LOCAL PLANNING PANEL – THE HILLS SHIRE COUNCIL

DETERMINATION OF THE LOCAL PLANNING PANEL ON 16 NOVEMBER 2022 – DETERMINATION MADE ELECTRONICALLY

ITEM 1: LOCAL PLANNING PANEL – PLANNING PROPOSAL – 21-23 VICTORIA AVENUE, CASTLE HILL (4/2021/)

This report presents the planning proposal for 21-23 Victoria Avenue, Castle Hill (4/2021/PLP), to the Local Planning Panel (LPP) for advice, in accordance with Section 2.19 of the *Environmental Planning and Assessment Act 1979*.

Figure 5

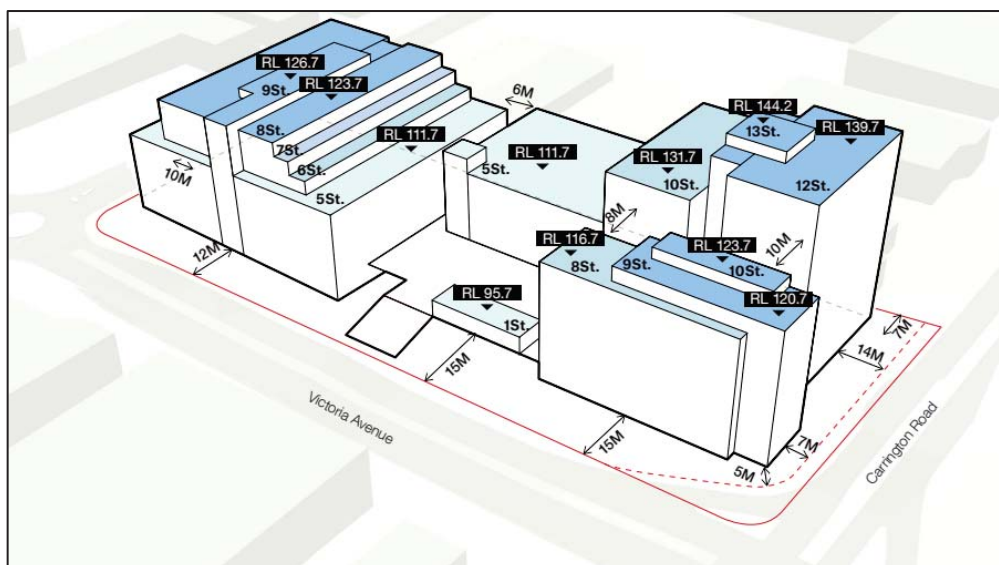
A portion of the southern corner and boundary of the site adjoining the intersection of Carrington Road and Victoria Avenue is zoned as SP2 Local Road Widening, for the upgrade and signalisation of this intersection. Since the land was identified for this purpose, further work has been progressed by Council with respect to the preliminary design of the intersection, including the provision of a slip lane along the southern corner of the site. This requires more land take from the subject site than is currently identified on the land zone map. The Proponent has sought to accommodate this revised boundary within their plans, though it is noted that reduced building setbacks are proposed to the revised boundary,

shown in the figure below. Should the planning proposal proceed, further negotiations with the Proponent would be required regarding the delivery of tangible public benefits in association with the uplift, such as dedication of the land required for the slip lane to Council at no cost.

Figure 7

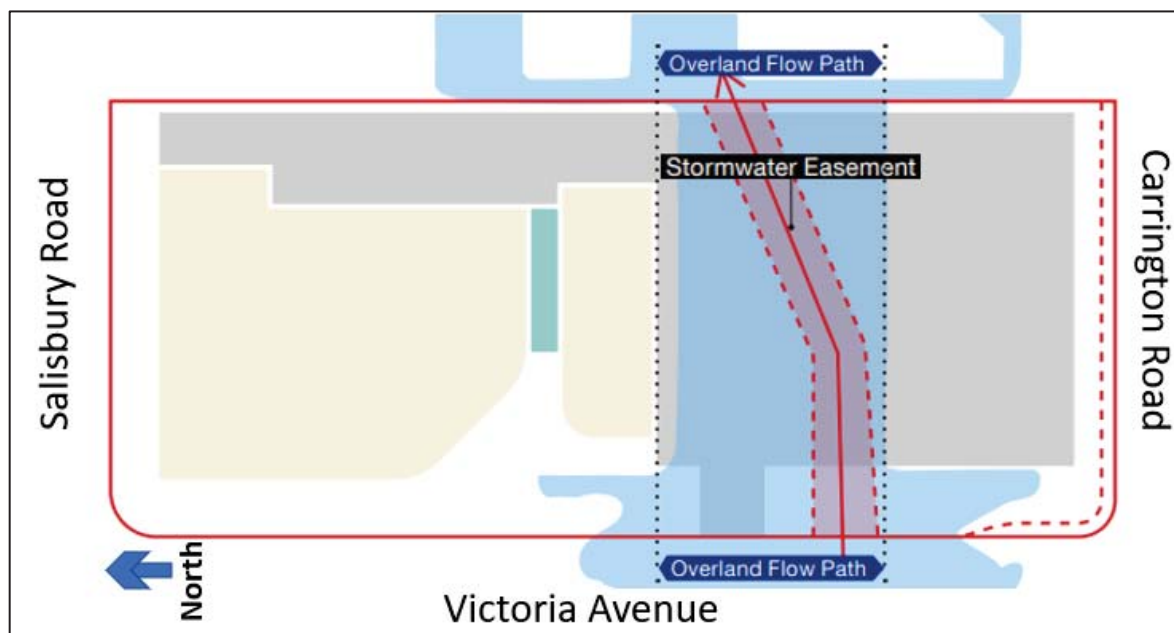
While various figures throughout this report, including material submitted by the Proponent, seek to illustrate the overland flow path, these are for indicative purposes only. The exact extent of the overland flow path cannot be verified at this point in time in the absence of a post-development flood model, which is still required to be submitted by the Proponent. The planning proposal would permit development in the overland flow path and also the within the 1% Annual Exceedance Probability (AEP) flood affected area. The indicative extent of the flood area is depicted in the figure below.

Ministerial Direction 4.1 requires that planning proposals not contain provisions which permit a significant increase in development in the flood planning area, being the 1% AEP + 0.5m freeboard. The site is located in the flood planning area. The planning proposal would permit an increase in density on land identified in the flood planning area and is therefore inconsistent with this Direction.

Figure 11

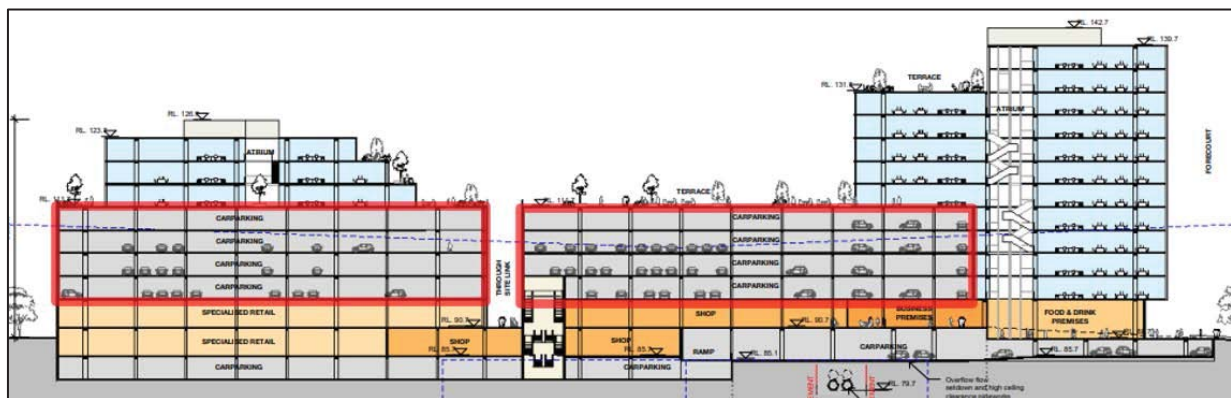
To illustrate this, Figure 11 below shows a section plan of the development, identifying the extent of parking areas proposed to be located within the building envelope.

Section of development concept marking up the above ground car parking outlined in red

Typically, other bulky goods developments in this locality are limited in scale (1-3 storeys) and provide car parking in either basement levels or at grade with landscaping. This means that the parking provided does not contribute to the bulk and scale of the development. Similarly, future high density commercial development (especially those in the realm of 2:1 and above) are generally expected to provide car parking in basement levels, not as part of the above ground building envelope, to minimise the bulk and scale of these developments.

While it is acknowledged that the proposed approach to the provision of car parking on this site has been driven by the site constraints, it nonetheless results in a bulky development that is visually imposing, out of character with the current and future character of the area and fails to create a positive streetscape with impacts affecting the quality of architectural design. The site constraints are a well-known factor which impact the site and must therefore be paramount in the planning and consideration of appropriate outcomes. In our view, the

Figure 12
Floor Plans of Development Concept (Basement to Upper Ground)

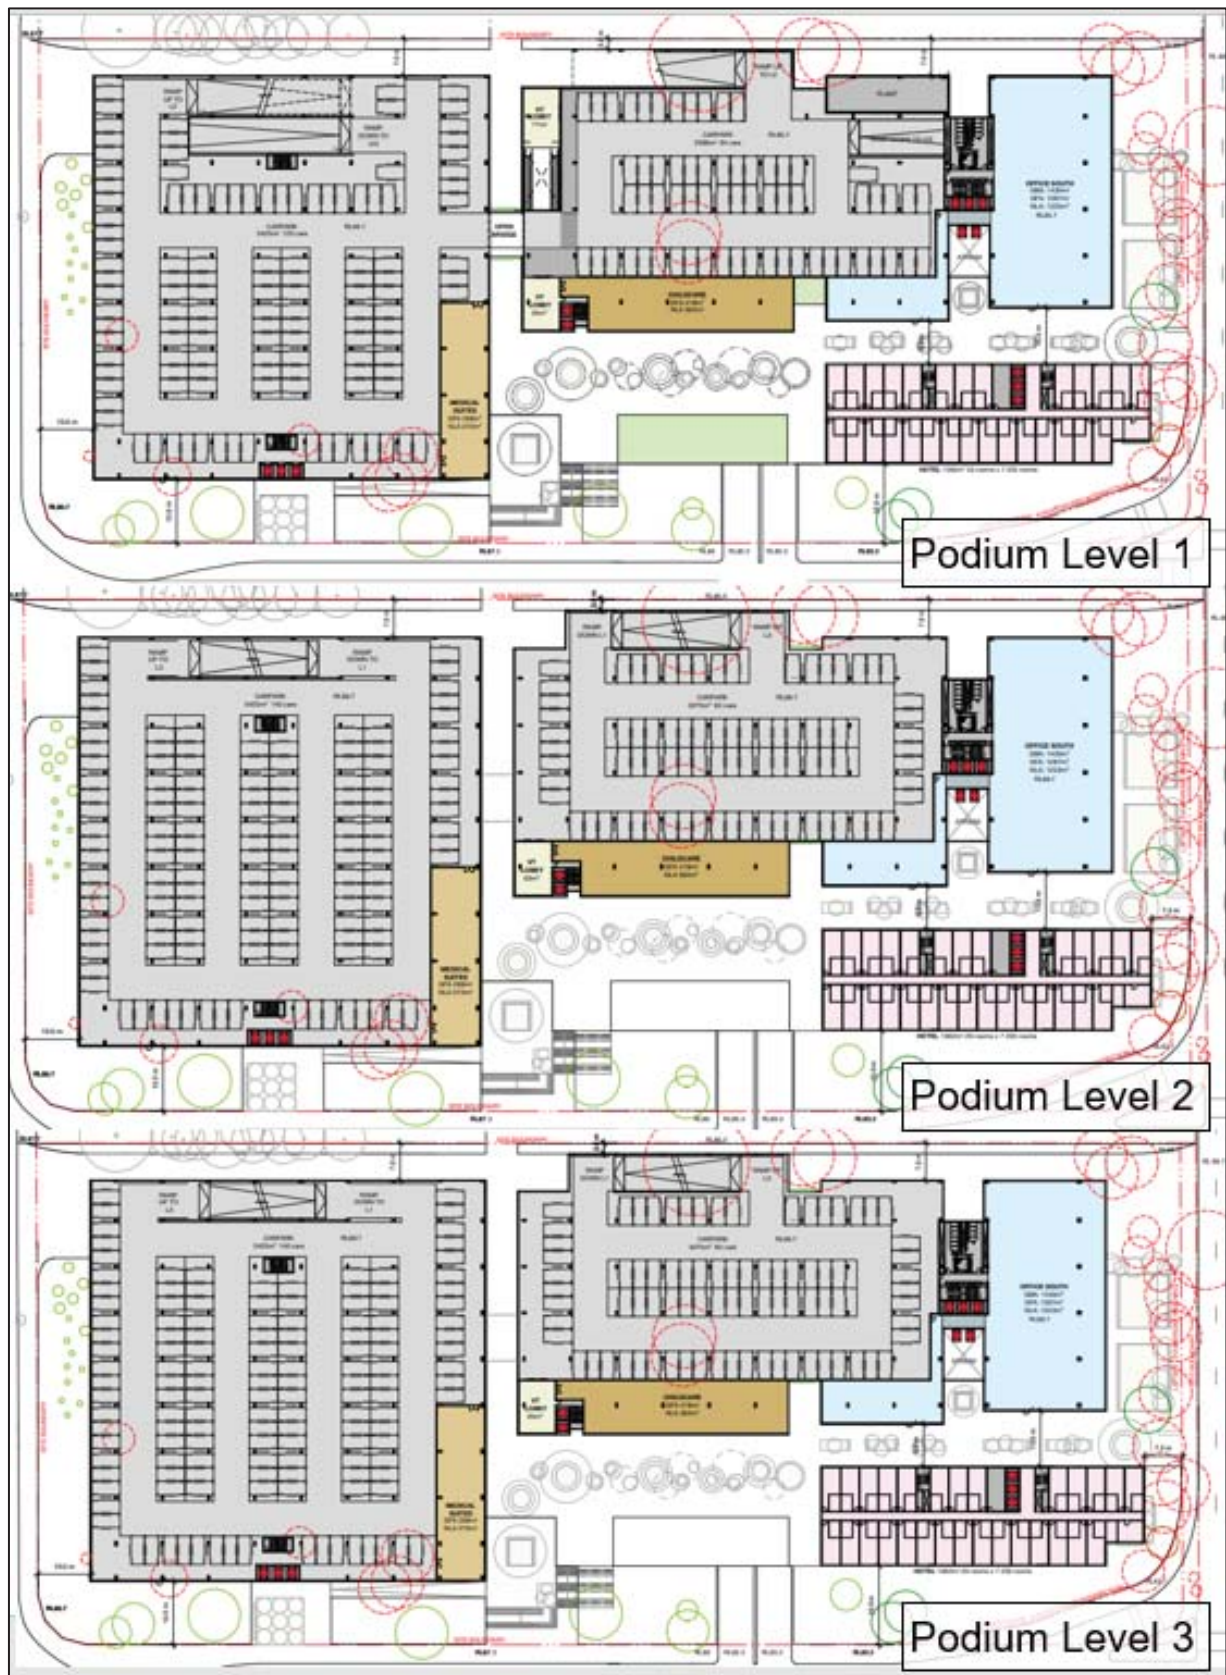
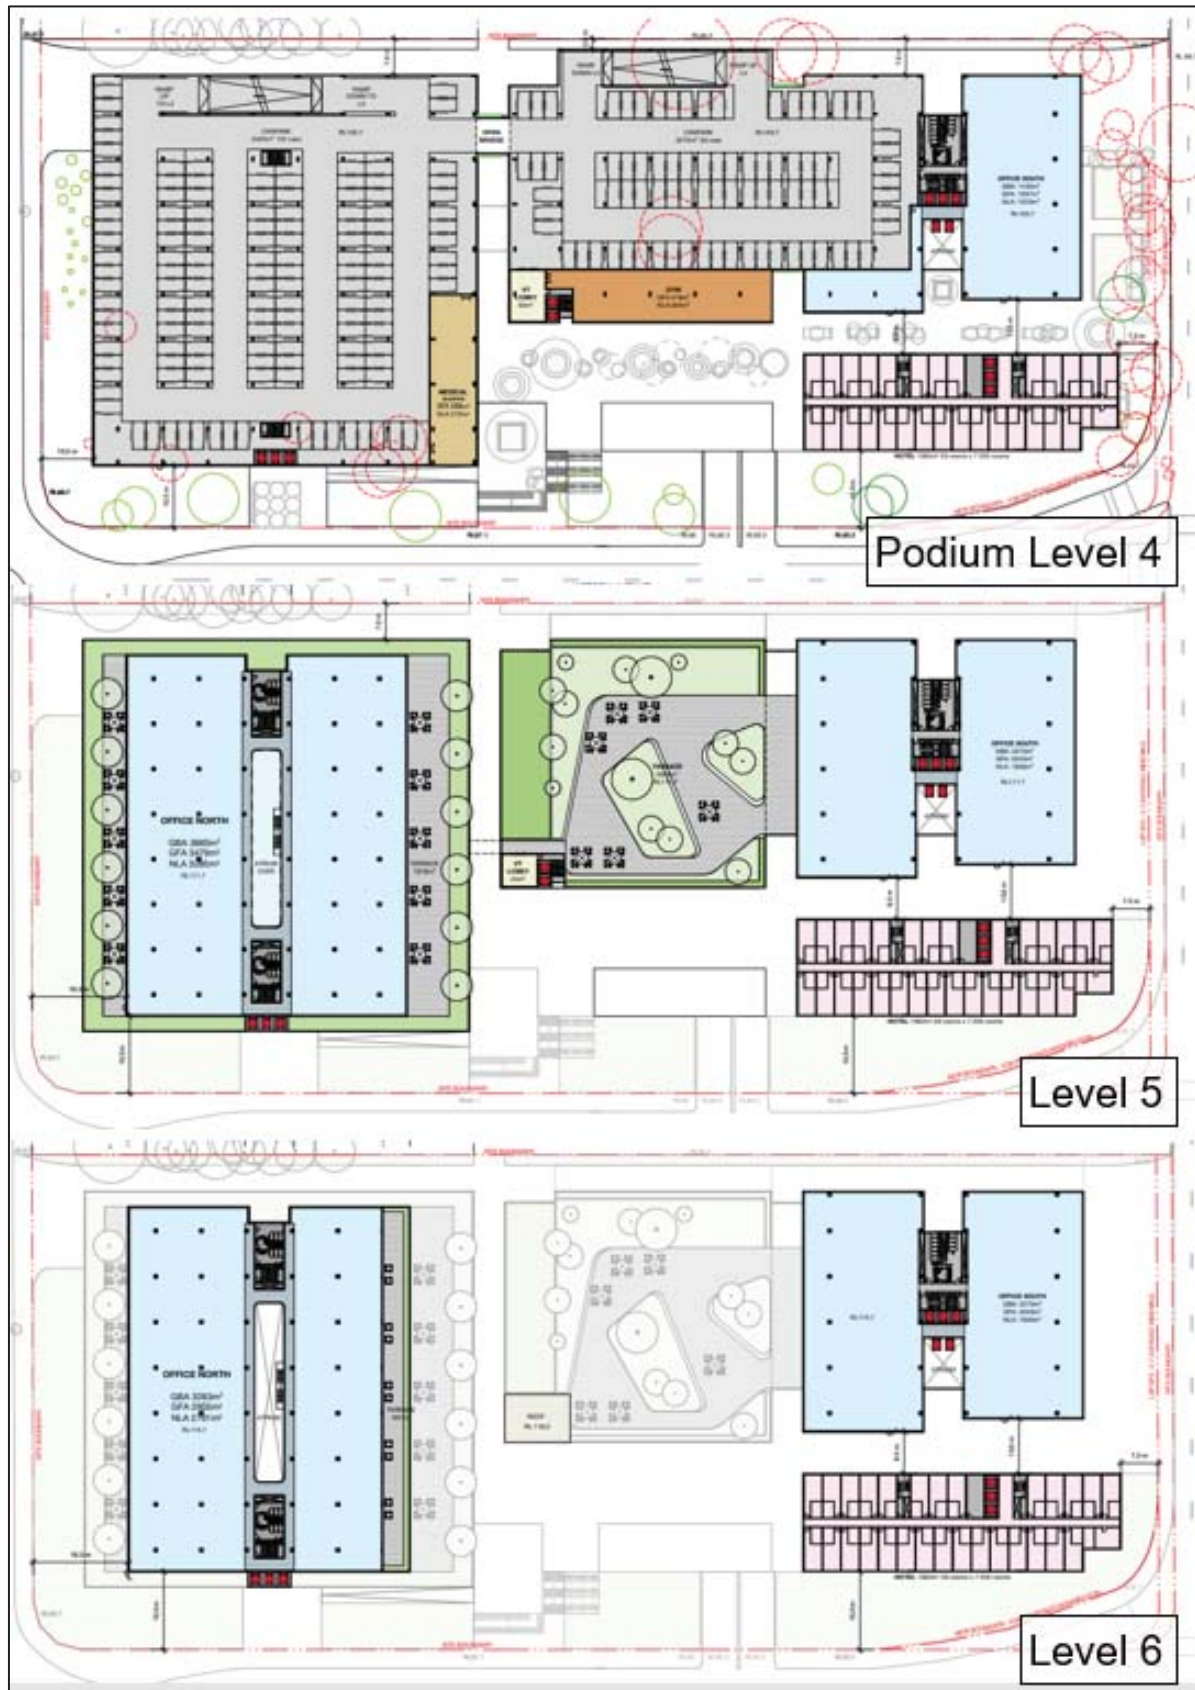
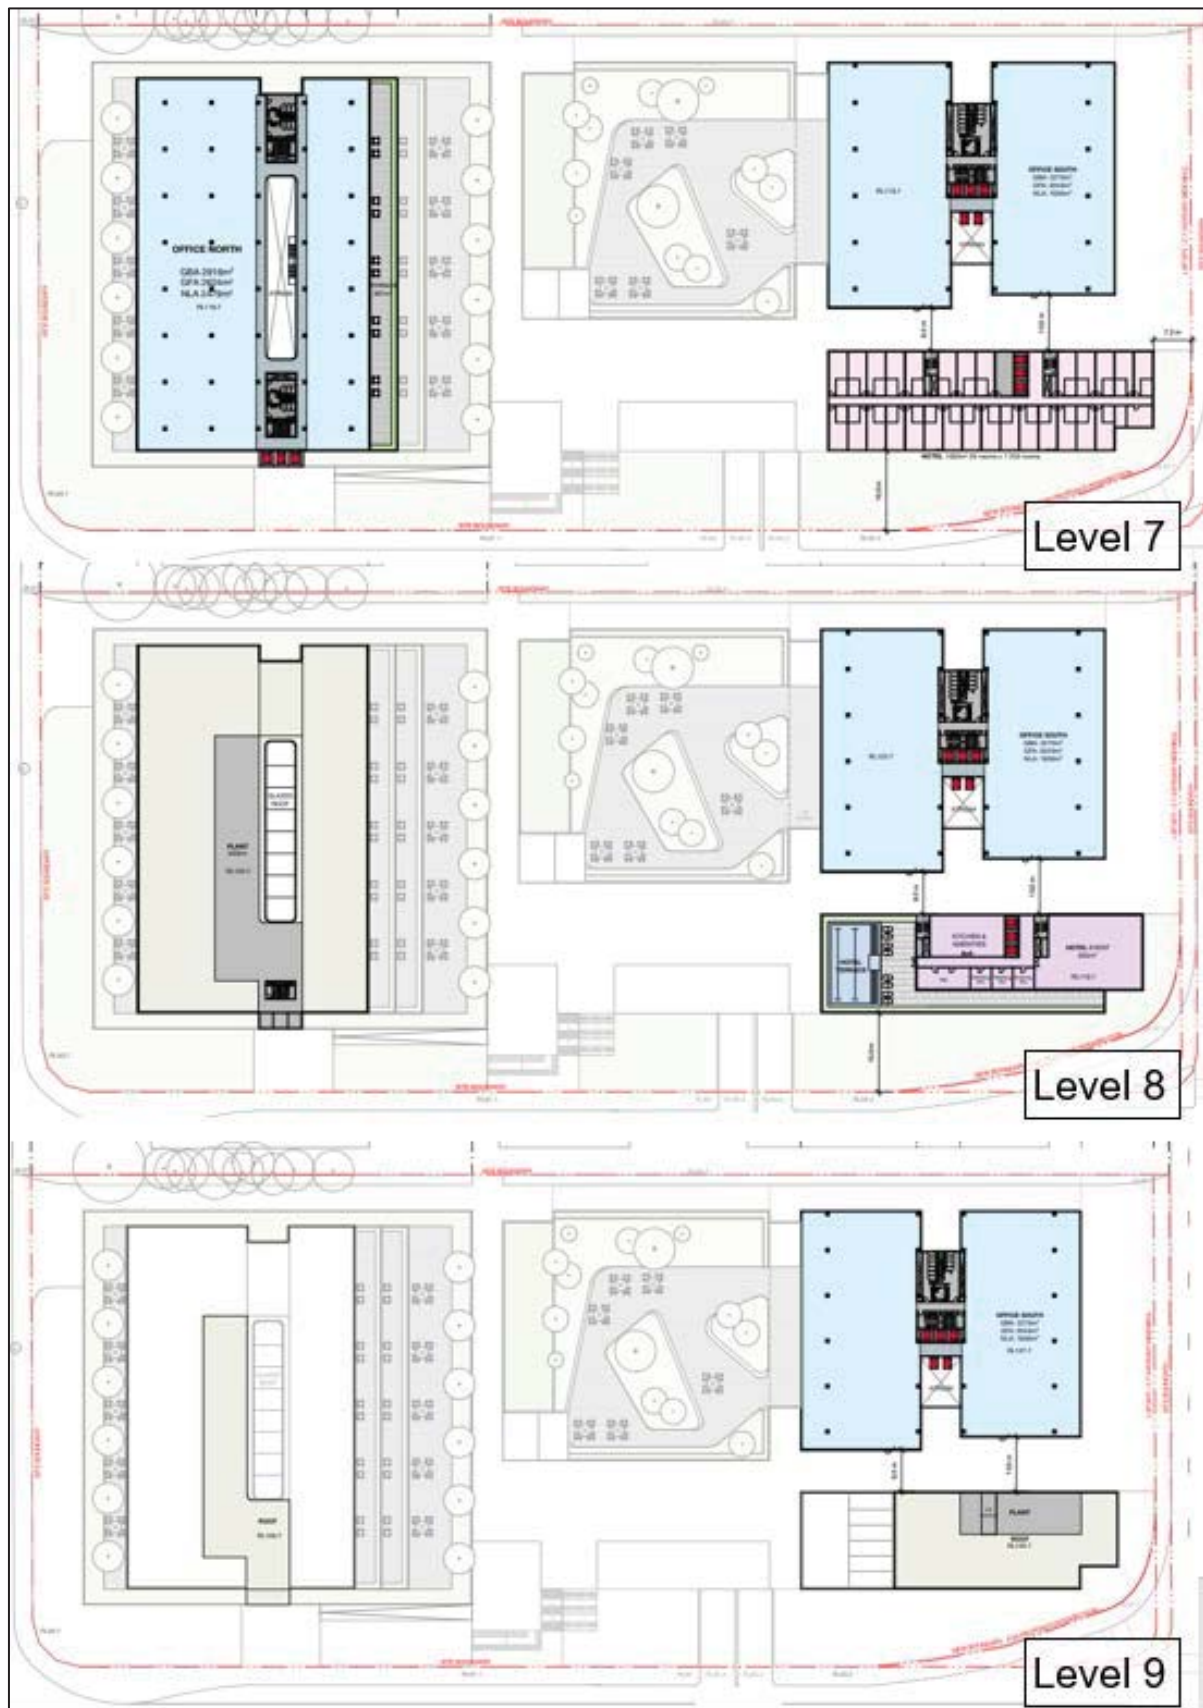
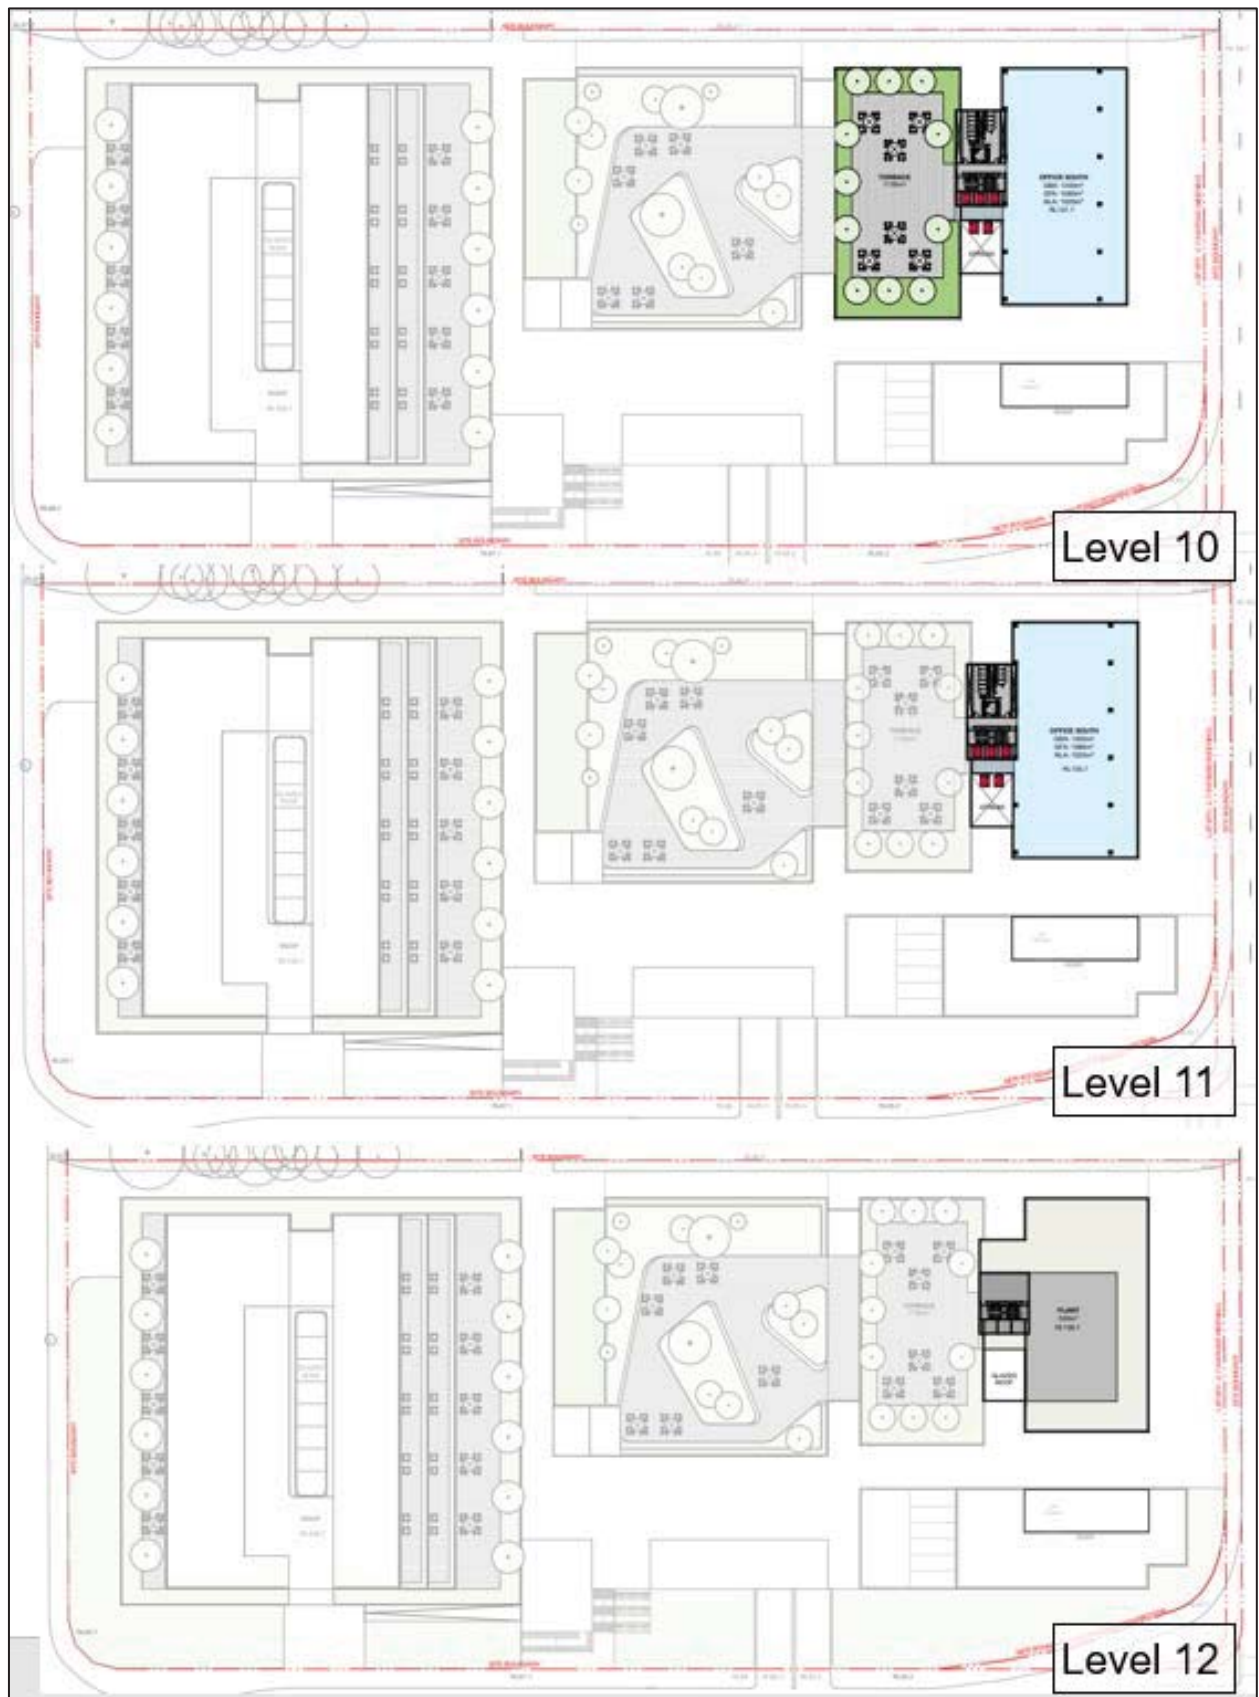
The following figures provide a level by level representation of the intended uses, which depicts the extent of building envelope that would need to be occupied by car parking if the proposed changes to the planning controls, as submitted by the Proponent, were to progress. As can be observed, this includes 4 storeys of large floorplates between the 3rd and 6th storey.

The floor plates associated with the proposed bulky goods retail uses (lower ground and upper ground) are very large, in the order of up to 5,000m², which is typical for bulky goods retail. The provision of these floor plate sizes to accommodate the continuation of retail outcomes on the site is supported. However, the extrusion of these floor plates for an additional 4-5 storeys, to accommodate car parking within the building envelope is problematic from a bulk and scale perspective.
